SUBJECT: Seabrook License Amendment Request on Concrete Degradation

UCS Comments on the ASR License Amendment Request

Figure 1: Map of Seabrook Site Showing Buildings Monitored for ASR Degradation

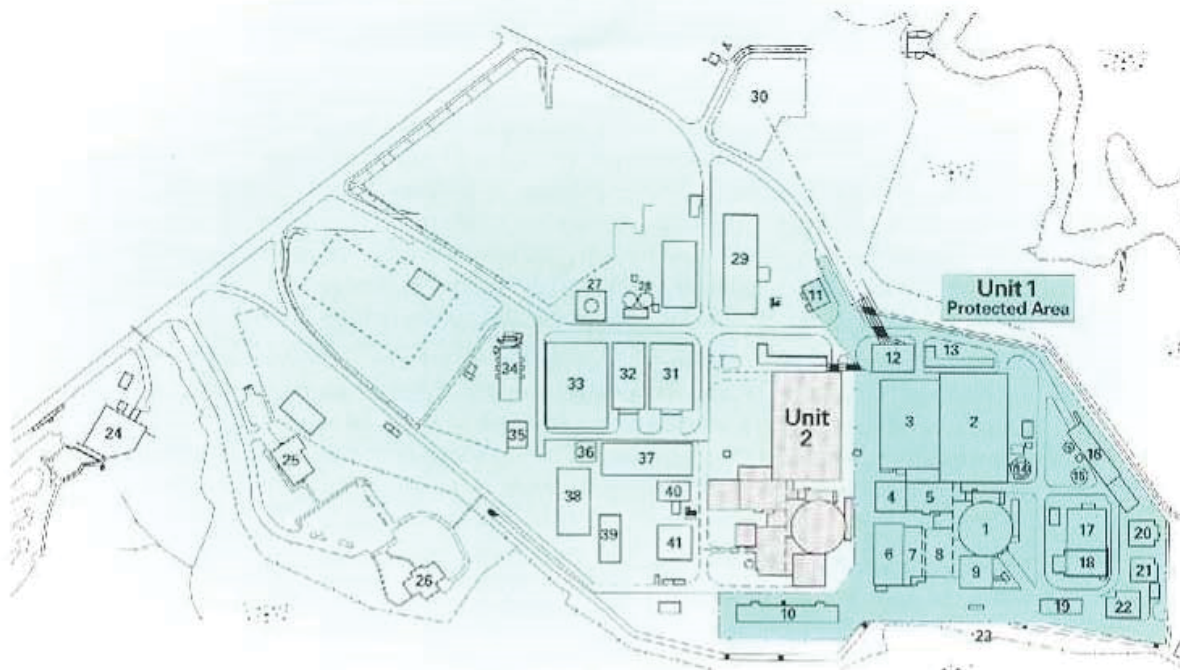
As Figure 1 shows, virtually all the buildings within the protected area for Unit 1 is susceptible to ASR degradation. It is far from a problem confined to only affecting one wall in one building.
